New Carpark – 5 Agnes St, Agnes Water (Lot 8 CP910294)

Assessment Manager
Gladstone Regional Council
Planning & Development
Application Number DA/4/2020

2. My objections in full. In this response I refer to Sections of Town Planning Report 5 Agnes Street Agnes Water 4PLA19181 13 February 2020 Prepared by Cardno (Qld) Pty Ltd and will be referred to as TPR below

P05 Photo Lot 8 CP 910294 showing bed level at 300mm below water level in the Wetland

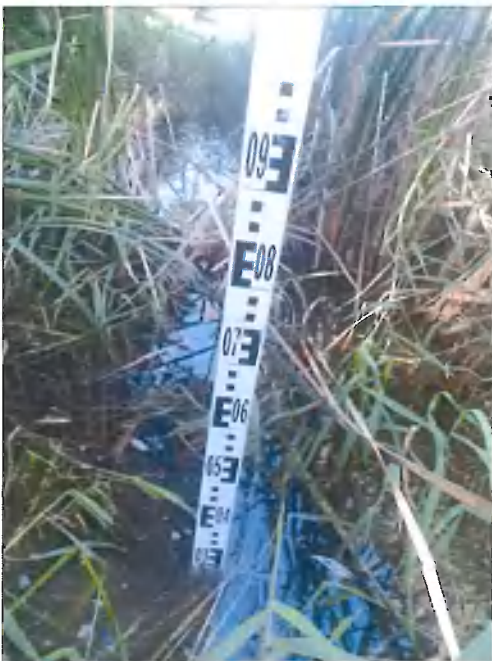
My response: the retaining wall design is located on a concrete footing 100mm thick. However this footing is located in a wetland on a mat of rotting vegetation, silt trapped by the riparian vegetation and acid sulfate soil The depth of which is over 700mm thick indeed a blunt survey staff can be penetrated by hand to that depth.

Works will not be allowed within Beachouses land therefore sheet piling will be required. The expense to fix this along with managing the acid sulfate soil will greatly blow out government grants and leave the Gladstone region community footing the bill. The design may or may not comply but it will not work.

P05 Photo Lot 8 CP 910294 showing bed level at 300mm below water level in the Wetland

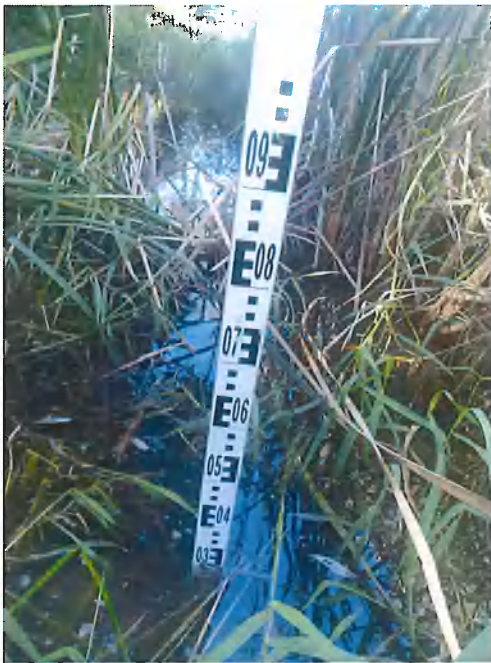
The depth of which is over 700mm thick indeed a blunt survey staff can be penetrated by hand to that depth.
